GIULIANO COTTAGE

16-2051
WESTMINSTER
Building Division APPROVED Plans
BY P. Banters DATE 8-23-16
AS NOTED & SUBJECT TO FIELD INSPECTION

GIULIANO COTTAGE
8029 JULIAN STREET
WESTMINSTER, COLORADO

C0

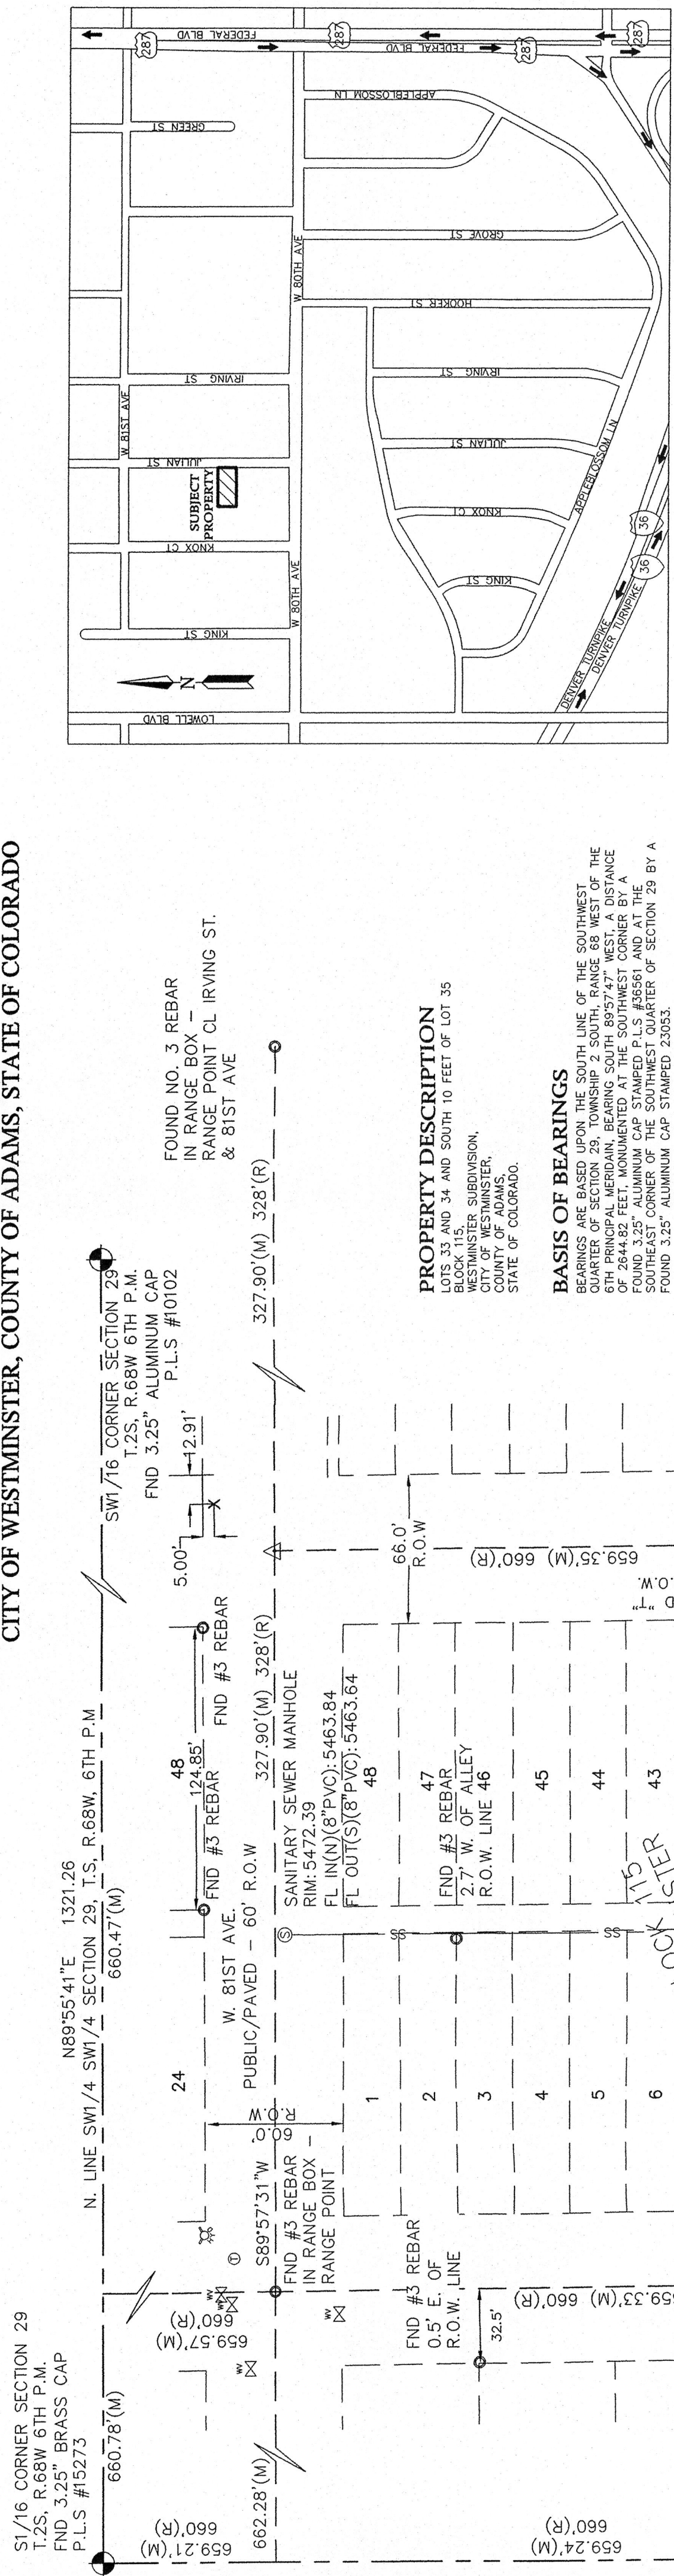
The water service line is NOT to be installed without City approval of the fire sprinkler system. Building Division rough inspections will NOT be approved until the fire sprinkler system rough inspection elements have been installed.

* OPEN HOLE INSPECTION
REQD. PROVIDE REPORT TO CITY
PRIOR TO PLACING FOUNDATION
WALL CONCRETE.

CONTRACTOR TO COMPLY WITH THE
CITY'S "STANDARD REVIEW COMMENTS
FOR RESIDENTIAL OCCUPANCIES"
PROVIDED WITH THIS PLAN SET

For Residential stand-alone fire sprinkler systems, a separate plan submittal and permit is required from the City Fire Department. Contact the Fire Dept, Mike Schafer, at 303-658-4544 for details.

AI

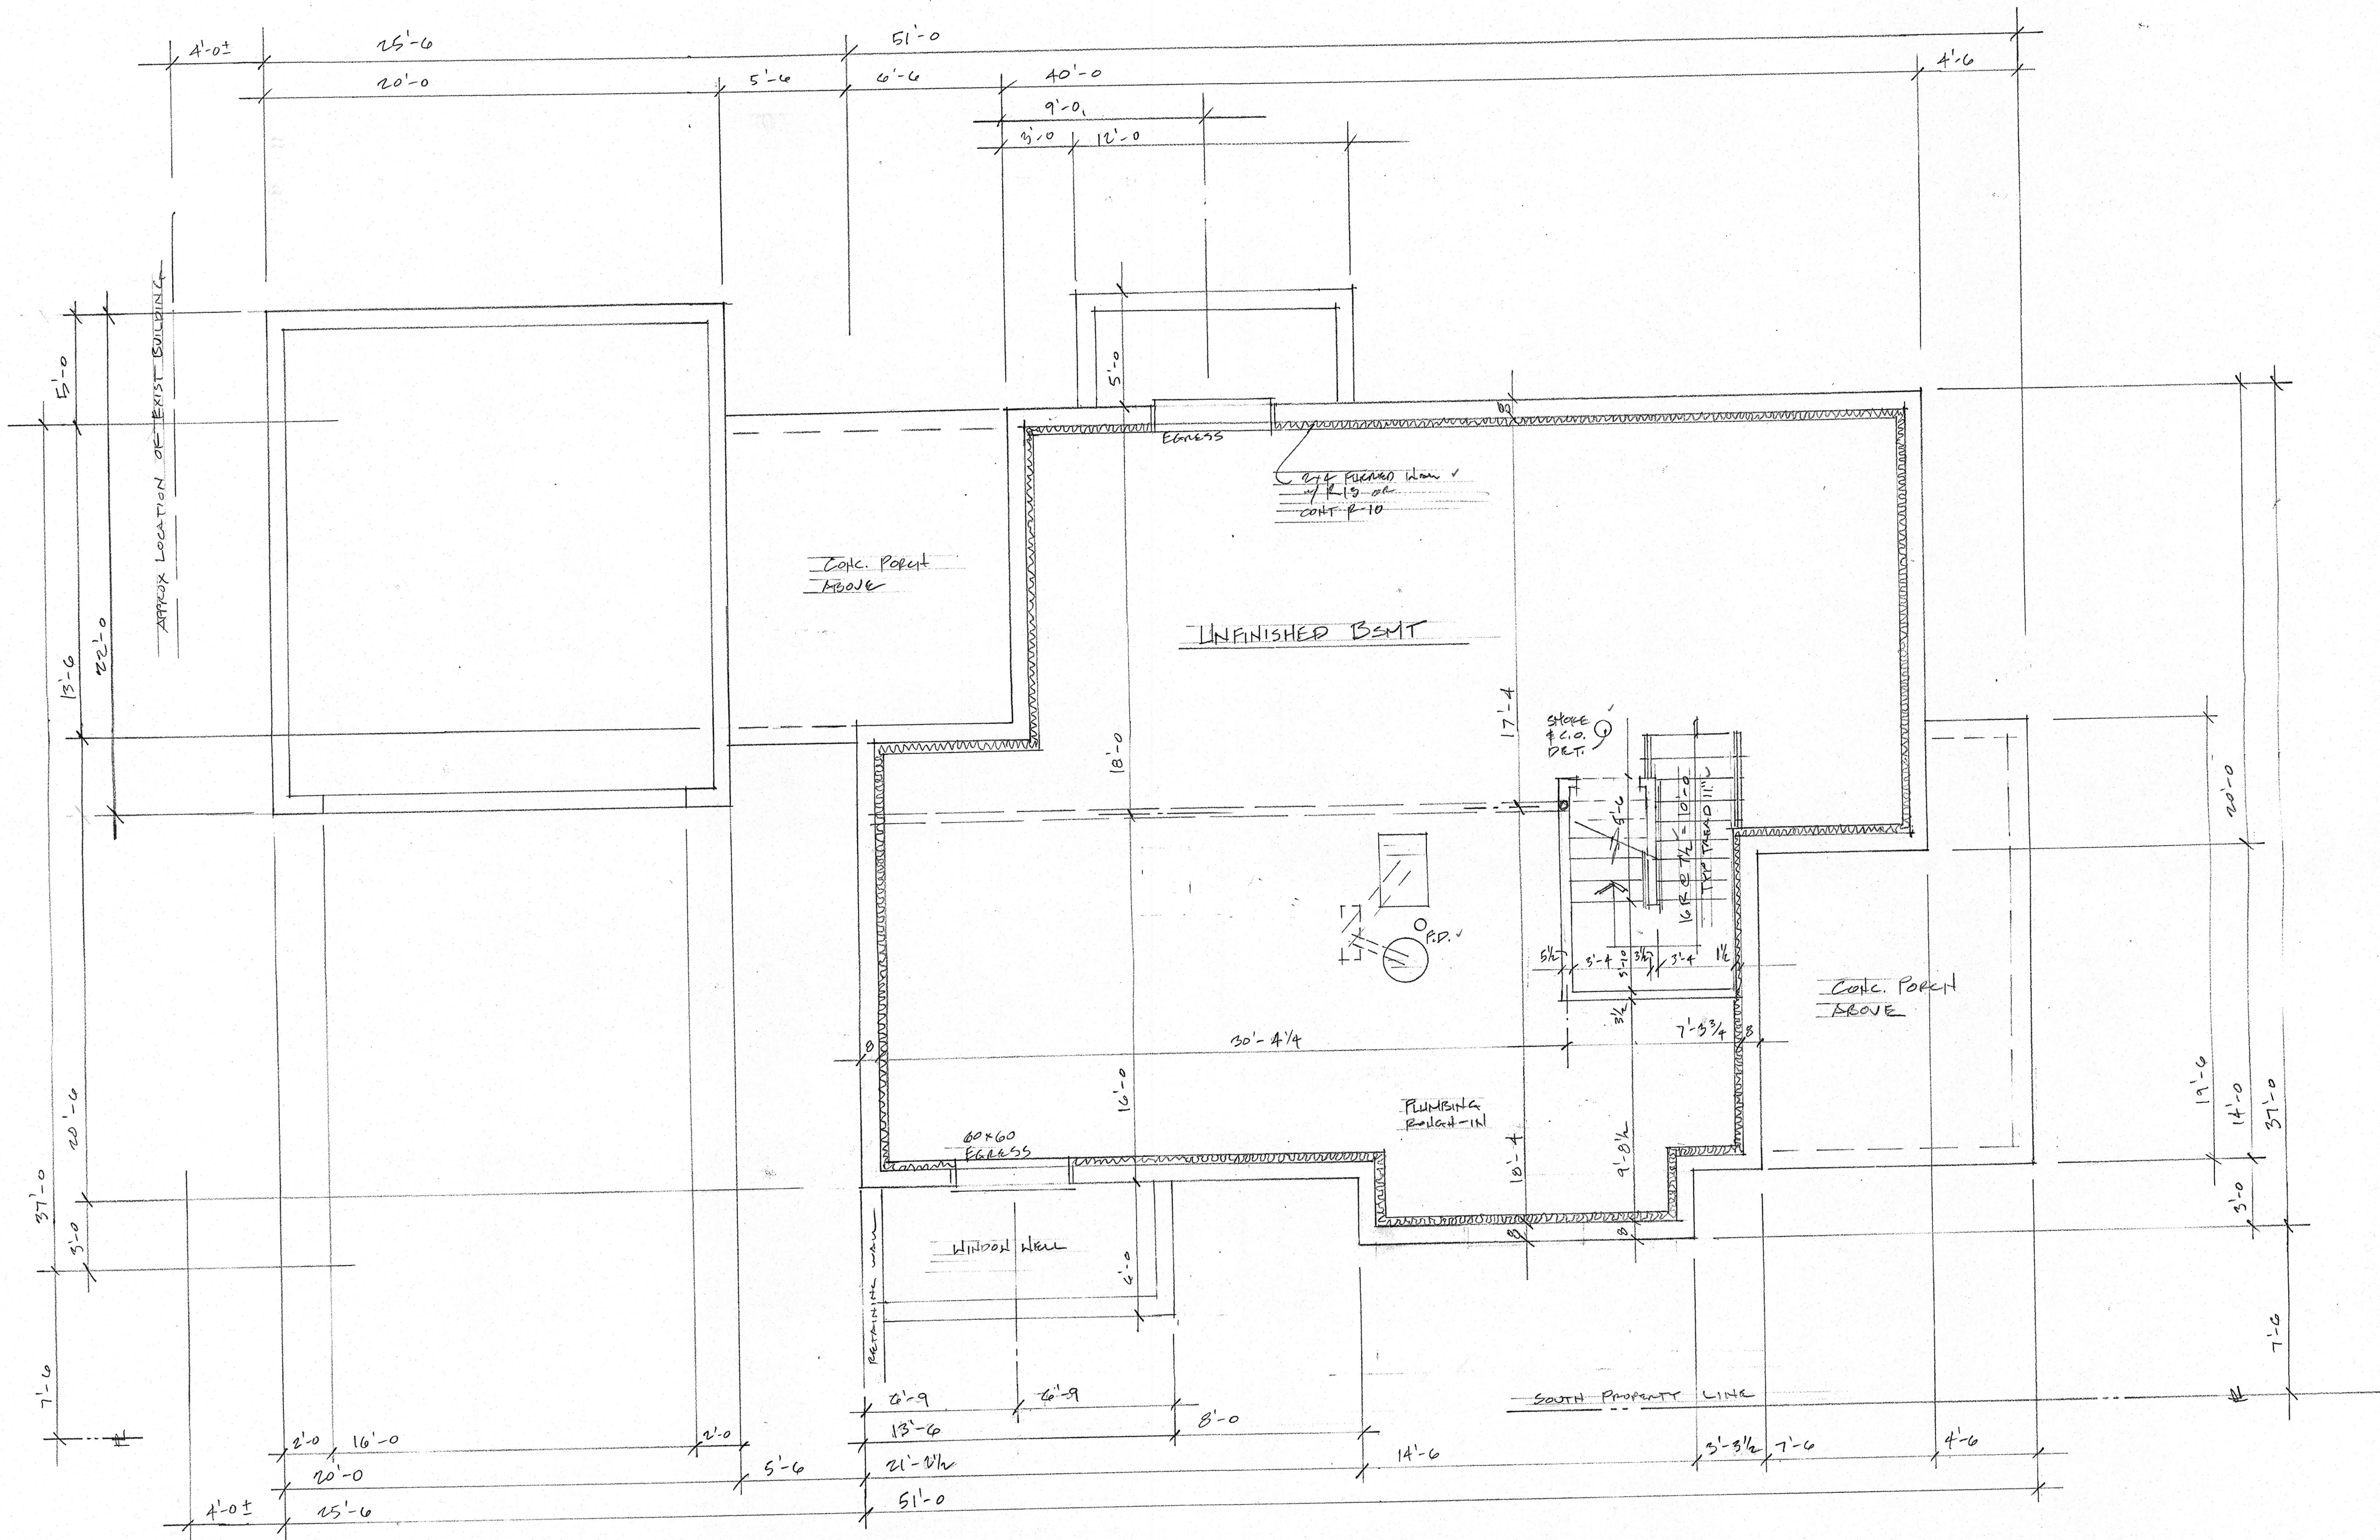
BSMT FLOOR IS CONCRETE S.O.G.
 FLOATING WALLS ARE REQUIRED.
 BOTTOM WOOD PLATE TO BE PT
 OR DECAY RESISTANT.

BASEMENTS WITH HABITABLE SPACE, HALLWAYS,
 BATHRMS, TOILET RMS, LAUNDRY RM SHALL HAVE
 A CEILING HEIGHT NOT LESS THAN 7'0". PORTIONS
 OF THE BSMT THAT DO NOT CONTAIN THOSE
 SPACES SHALL HAVE A MIN 6'8" CEILING HEIGHT.
 BEAMS/ DUCTS/ PIPES AND OTHER OBSTRUCTIONS
 MAY PROJECT TO WITHIN 6'4" OF FINISHED FLOOR.

REQD IN MECHANICAL ROOM:
 - FLOOR DRAIN
 - GFI OUTLET WITHIN 25' OF GAS FIRE
 APPLIANCES
 - LIGHT SWITCHED FROM ENTRY DOOR
